Modification 6 of Westlink Industrial Estate Stage 1

State Significant Development Modification Assessment Report (SSD-9138102-Mod-6)

May 2025

Figure 4 | Modified Site Layout

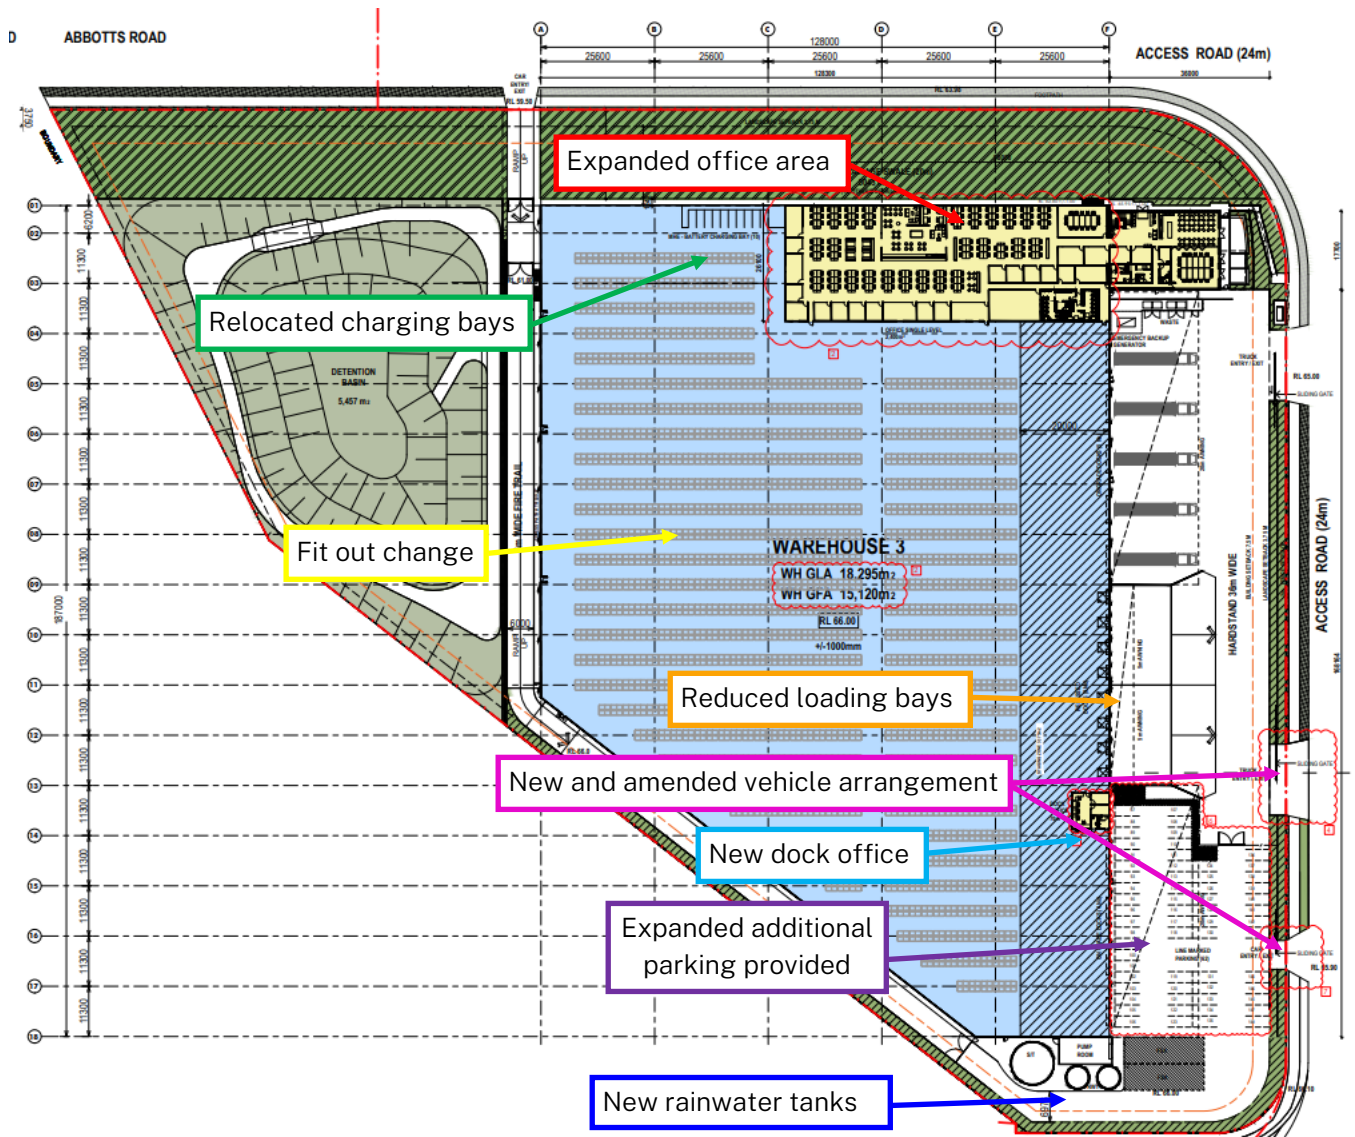
Council also noted that the proposed additional car park is separated from the proposed extended office space by the loading bays and requested the Applicant to reconsider the positioning of the carpark or provide safe internal pedestrian paths in order to remove the risk of vehicle/pedestrian conflicts.

Additionally, Council requested swept paths diagrams to indicate the manoeuvrability of 30m A-double vehicles entering the loading bays.

- justification that the proposed increase in office GFA would ensure the office component remains ancillary to the development.
- clarification around the usage of the additional car park. The Applicant noted that swept path plans had been provided in Attachment 1 of the Traffic and Transport Statement (Appendix F of the Modification Report).

Findings and conclusions	Recommended conditions
<p>facilitate improved traffic capacity, which are appropriately sized to accommodate the traffic generation from the approved development and the proposed modification.</p> <ul style="list-style-type: none"> The Department concludes the estimated increase in vehicle movements are negligible and would not have a detrimental impact on the operation of the subject site, WIP, or the broader MRP. 	
Parking	
<ul style="list-style-type: none"> The proposed modification involves a new overflow car parking area for Warehouse 3 at the south-western portion of the existing hardstand that would increase the parking provisions from 85 to 146 (an additional 61) spaces. Car parking rates for Warehouse 3 have been assessed for 1 space per 300m² for warehousing (50 spaces) and 1 space per 40m² for office use (62) as per the MRP DCP requirements, resulting in a minimum requirement of 112 spaces. The total number of spaces proposed under the modification is 146. The proposed additional carpark has been located on the southern portion of the warehouse to reduce impacts to loading operations given the shape and layout of the warehouse. Additionally, the existing lower ground floor carpark is intended to be utilised by office workers, and the proposed overflow carpark is to be utilised by warehouse workers. A Pedestrian Access Plan was provided with the additional information and indicates the routes workers would take from the proposed carpark. The carpark is located adjacent to the southern portion of the warehouse, which renders the four southernmost dock bays inoperable. However, the bay doors are still proposed to be provided, should any future tenant require them in lieu of the proposed carpark. The Department considers that the proposed number of car parking spaces meets the requirements of the MRP DCP and the configuration would not cause adverse impacts on traffic or pedestrian safety. The Department concludes that the proposed overflow carpark is proposed to facilitate the requirements of the tenant and is provided in such a way that potential future tenants may remove the carpark and utilise the loading bays. 	No additional conditions recommended
